Planning and Development Services Division Issues Report

Petition: **P.Z. 05-2016 Wildhorse Baxter Center, C148B (Shelbourne Senior Living):**
A request for a zoning map amendment from a “C-8” Planned Commercial District to a “UC” Urban Core District for 5.21 acres located south of Wild Horse Creek Road and east of its intersection with Baxter Road (18T630283).

RE: PZ 05-2016 Wild Horse Baxter Center, C148B (Shelbourne Senior Living)

Figure 3. Existing Contours

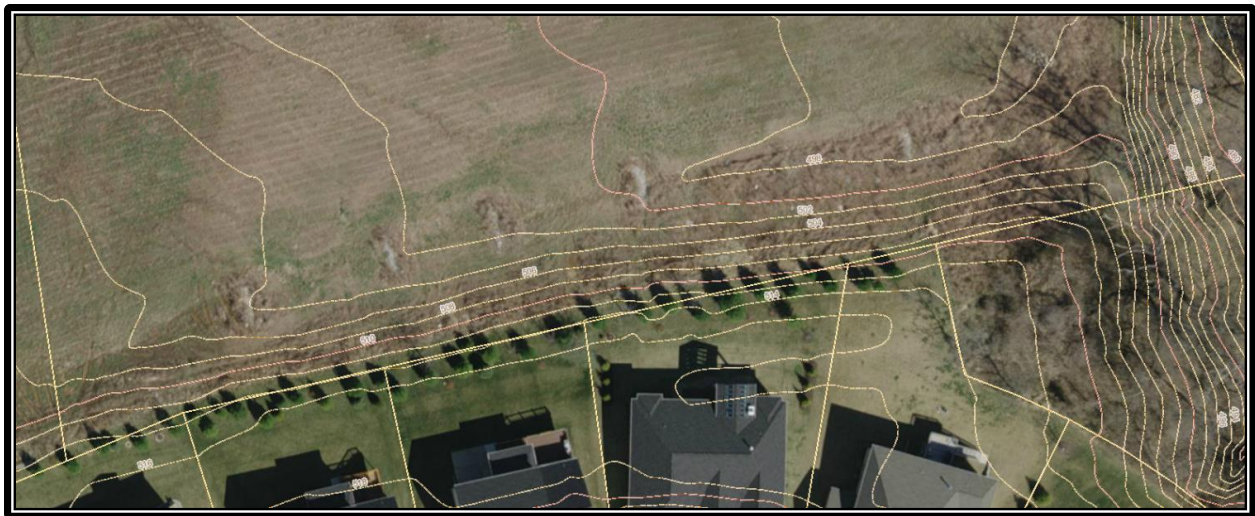
5. *Due to the topography of the subject site in relation to the adjacent sites, concern regarding the adequacy and effectiveness of the proposed 30' landscape buffer was expressed.*

The image above shows existing contours on the site. The existing residential homes to the south of the subject site sit at a higher elevation than the proposed development. While this helps mitigate the difference in height (see Issue #3), the change in topography also minimizes the effectiveness of landscaping and other methods for screening.

The Petitioner has provided a response that landscape screening would be more effective on the neighboring property due to the topography and that they are willing to work with the adjacent property owners to install landscaping and other screening on those properties. Staff agrees that

landscaping installation at a higher elevation would be more beneficial; however, we are not aware of an agreement that would permit the installation on the neighboring property.

A conceptual landscape buffer exhibit was provided and the impact of the landscape buffer is evident on the provided section profiles. The conceptual landscape buffer shows landscaping along this property line, concentrated to the south as much as possible to provide landscaping on higher elevations.

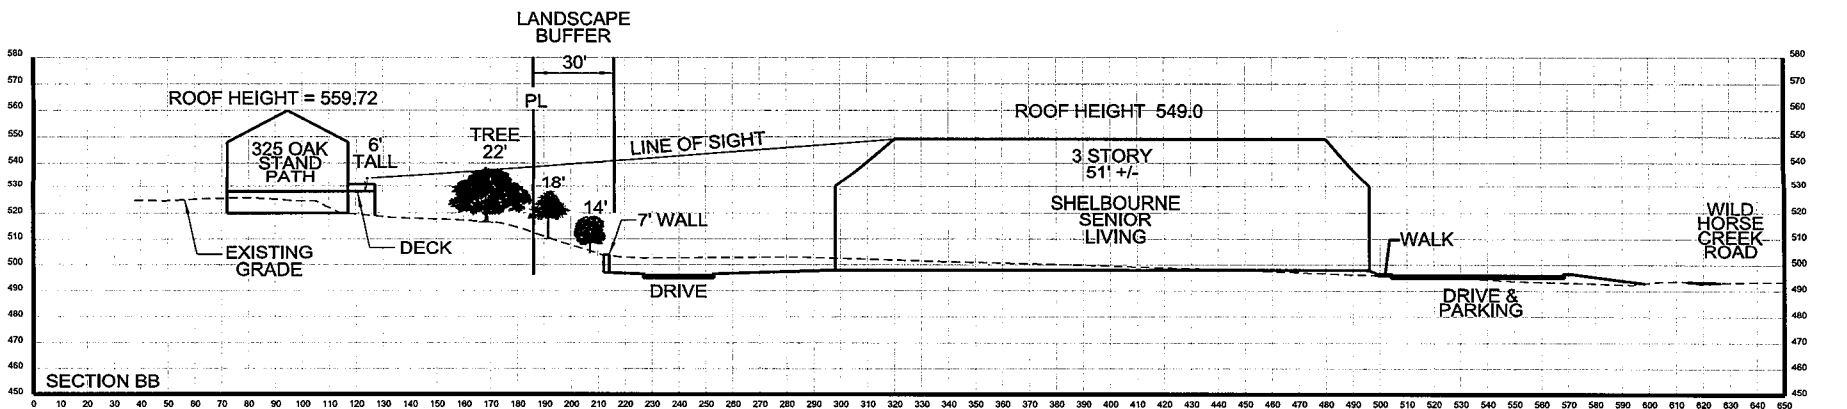
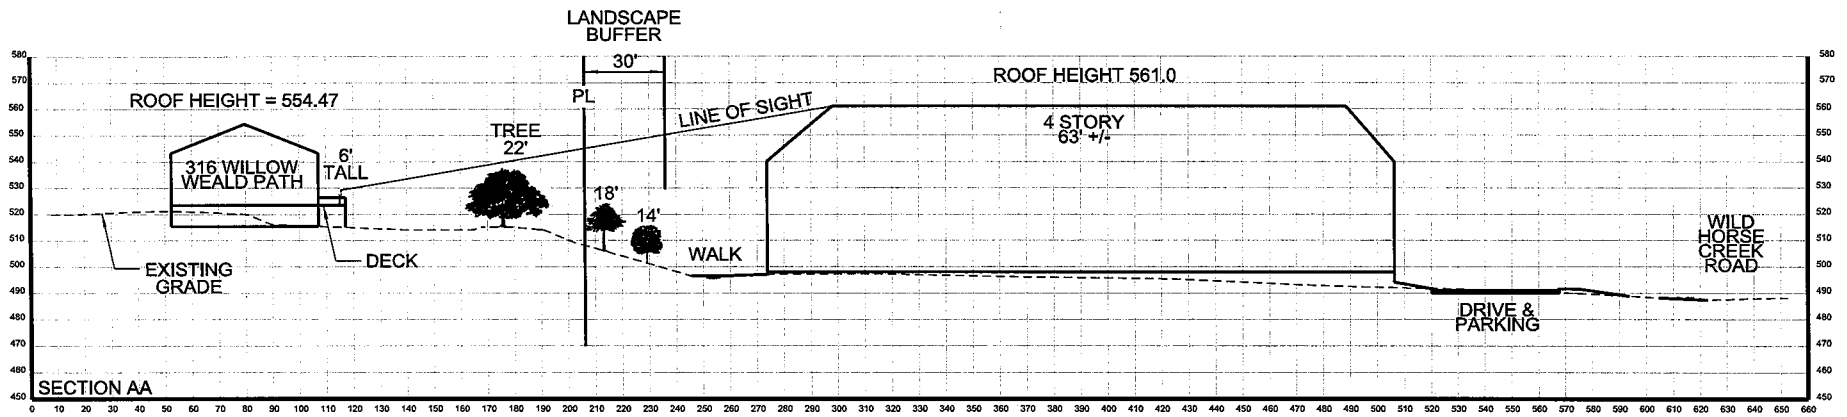
3. Concerns were expressed regarding the proposed height of the facility. Provide a height comparison of the proposed maximum building height to other nearby buildings including, but not limited to, the Jewish Community Center and the Seventh Day Adventist Church.

3. Concerns were expressed regarding the proposed height of the facility. Provide a height comparison of the proposed maximum building height to other nearby buildings including, but not limited to, the Jewish Community Center and the Seventh Day Adventist Church.

The response indicates, and the section profiles show, a reduction in maximum height of the proposed structures to 63 feet (the response indicates the maximum height was previously 73 feet). These values are shown on the map on the next page for spatial comparison. Please note, all decimals were truncated for clarity in the image. Arrows, when used, show the location of a feature and its location on the lot.

The requested height comparison is provided with this letter. In addition, please be advised that the original maximum height of the proposed building was 73 feet. Petitioner made a design change that has reduced the maximum height of the proposed building to 63 feet.

Height Comparison:

CONCEPT - LANDSCAPE BUFFER
SCALE: 1"=40'-0"

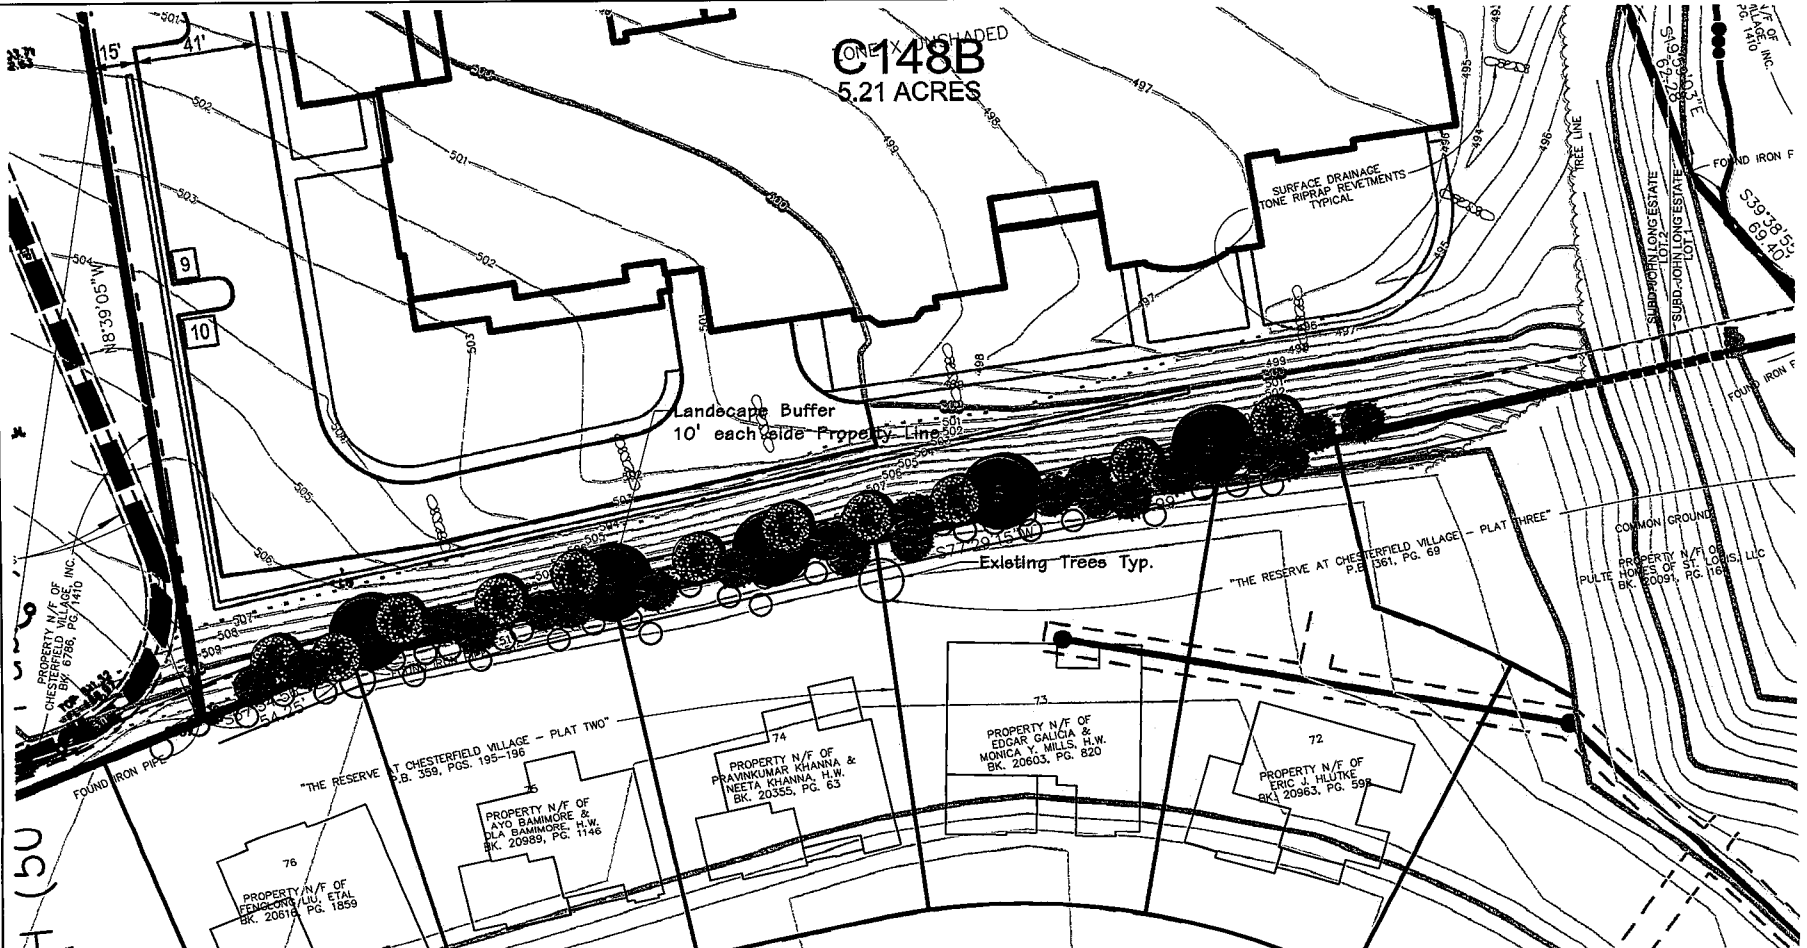
5. Due to the topography of the subject site in relation to the adjacent sites, concern regarding the adequacy and effectiveness of the proposed 30' landscape buffer were expressed.

In addition to installing landscaping in the 30 foot buffer that is compliant with the City's requirements (see colored landscape buffer concept provided with this letter), Petitioner has offered and still offers the Homeowners' Association of The Reserve at Chesterfield the sum of \$20,000 for plantings, fences or other screening at 311 and 325 Oak Stand Path, and 300, 308 and 316 Willow Weald Path and an additional sum of \$2,000 for landscape design. Because of the topography, plantings, fences or other screening would be more effective if installed at the elevation of the rear of those properties.

PRELIMINARY DEVELOPMENT PLAN

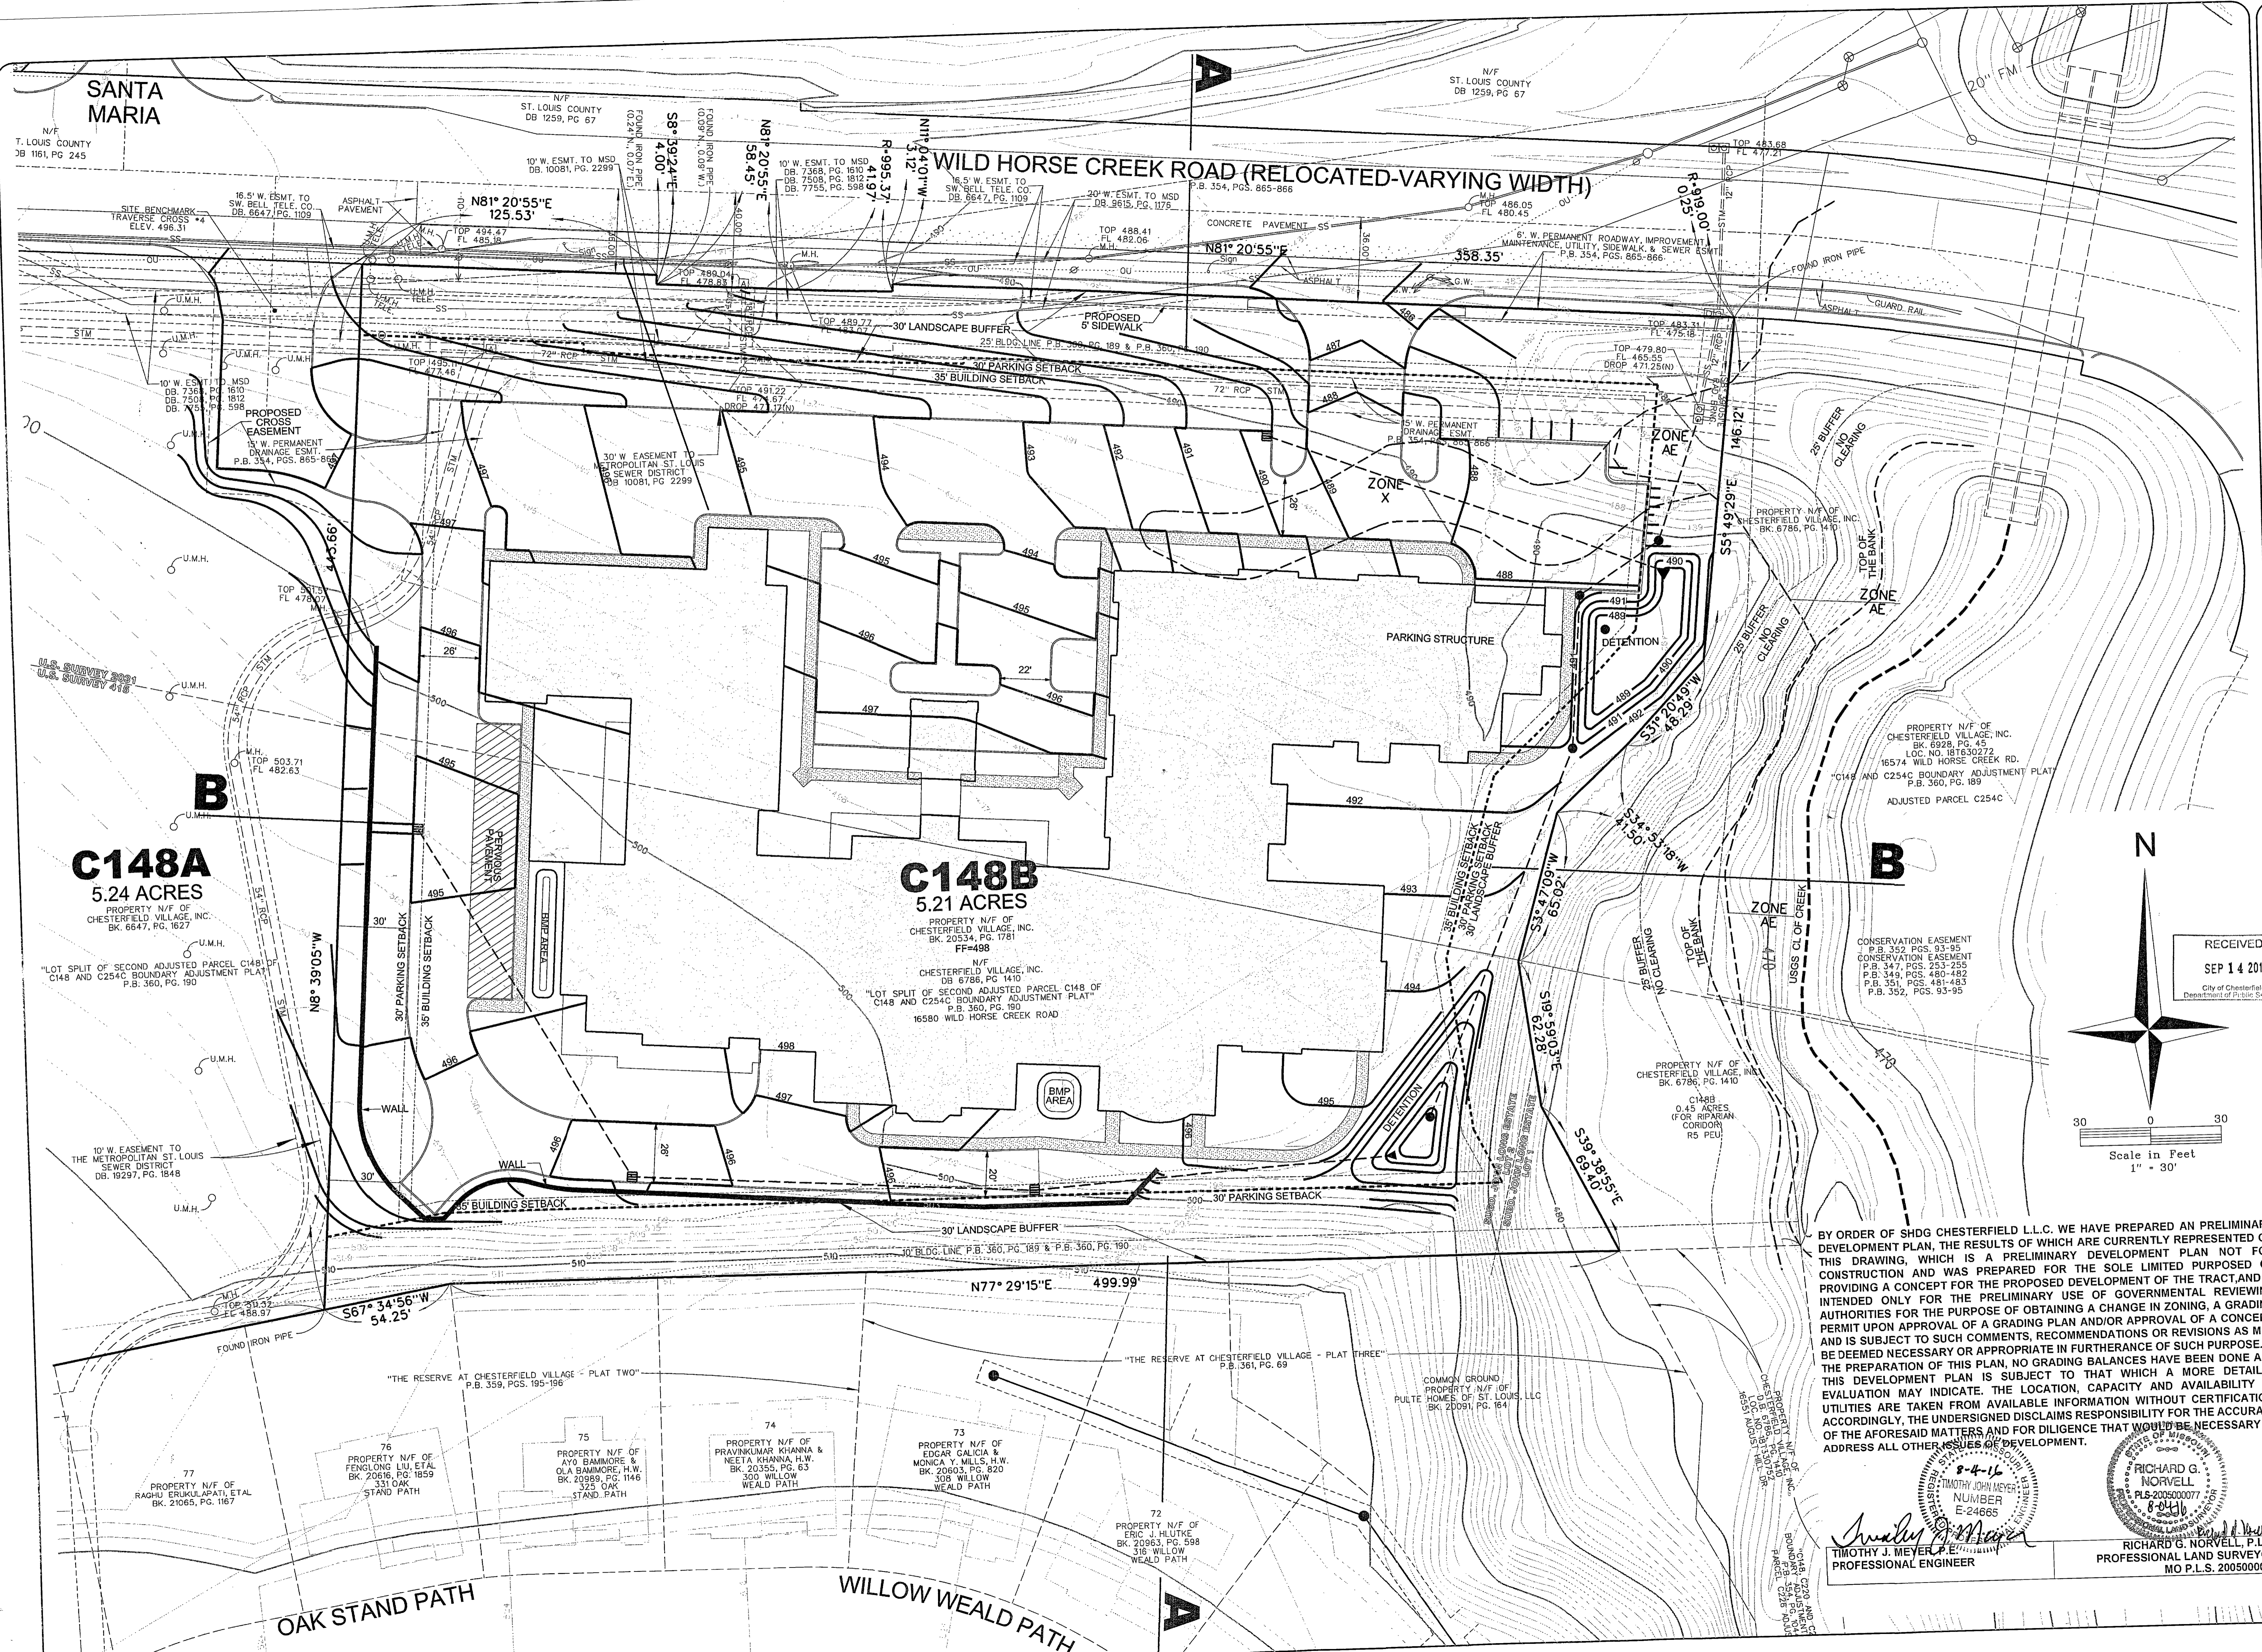
- **Site Access** – Access to the site is proposed utilizing two existing curb cuts off Wild Horse Creek Road. The westernmost entrance is located on an adjacent parcel and is proposed via a cross access easement. The existing location of the curb cut does not comply with access management requirements in the UDC. The City and St. Louis County have commented that the location should be moved directly across from Santa Maria Dr. (a private street). This revised configuration would alleviate dangerous opposing left turn conflicts. In response, the Petitioner has indicated this entrance is located on an adjacent site and that the plan utilizes the existing condition. Staff has concerns about allowing new development to utilize non-conforming entrances and adding additional traffic to these locations. If the subject site is not permitted to relocate the drive to a complaint location, Staff would recommend limiting the subject site to one curb cut located on the subject site to alleviate the number of cars that would be utilizing the non-complaint curb cut.

- **Eastern Landscape Buffer** – The Preliminary Plan depicts detention facilities located within the required 30 foot landscape buffer along the eastern property line as portions of the property to the east are zoned "LLR" Large Lot Residence District. The Petitioner has responded that, through the zoning process, they will be seeking a modification to this

1. Revise the location of the proposed western entrance to align with Santa Maria Drive per the City of Chesterfield and St. Louis County.

2. The placement of detention areas along the eastern property line appear to prevent a continuous landscape buffer. A 30' landscape buffer is required in this area per Section 04-02 of the Unified Development Code. Revise as necessary.

3. Detention basins need to discharge at natural discharge points. According to the preliminary storm sewer information on the submitted plan, the detention basins will be piped to drain onto existing slopes that are not natural discharge points. The site currently drains toward the northeast corner of the property. The proposed drainage and discharge should also then drain to and discharge in the northeast corner of the site.

4. A sidewalk is required along the entire length of Wild Horse Creek Road per Section 04- 08 of the Unified Development Code. Revise the plan to meet this requirement.

5. Wild Horse Creek Road is designated a major arterial and the driveway throat length (from the edge of pavement to the point of first conflict on the site) shall be a minimum of 80 feet per Section 04-10 of the Unified Development Code. The driveway throat length shall be measured from the final location of the edge of pavement for this development. Provide a measurement for the western entrance and revise the measurement for the eastern entrance to utilize the proposed edge of pavement to meet the driveway throat length requirement.

6. Remove the minor instances of parking lot striping including the handicap striping.

requirement. They cite the existence of a large landscape conservation easement to the east of the subject site; removing the ability to develop this property in the future. Staff does not have any concerns with the request.

The Western entrance is already permitted and constructed and is located on adjacent property that Petitioner does not own or control. Petitioner's plan contemplates using that already permitted and constructed entrance.

The Eastern property line of the subject property abuts a permanent conservation easement so no residential development will ever occur there. By separate letter Petitioner will request a modification of the landscape buffer requirement in this area.

See revised plan.

See revised plan.

See revised plan.

See revised plan.
